McCULLOCH CORPORATION
SERVICE BULLETIN

1561

SUBJECT: Fuel Cap Venting With All Weather Cover

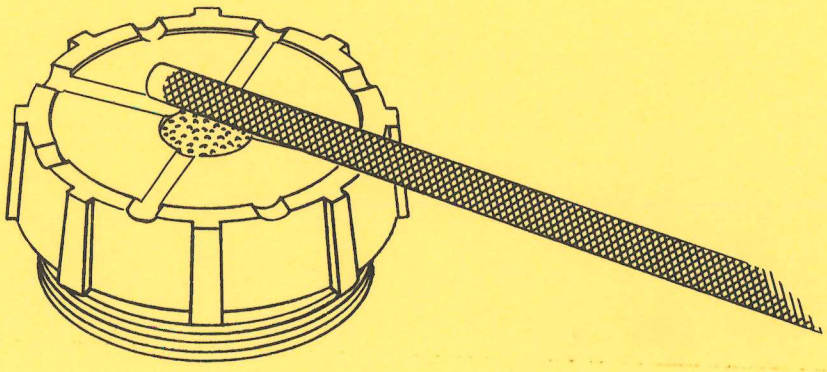
When the all weather fuel cap Cover, P/N 83651, is used on Fuel Cap, P/N 55934B, the cover may fit so tightly against the top of the cap that it will not vent.

To be sure that there will be proper venting when the cover is used, just file a couple of shallow grooves across the face of the cap as illustrated. Do not file into the filter.

Only a very shallow groove for air passage is needed and a small rat-tail chain file (1/8" or 3/16") is suitable.
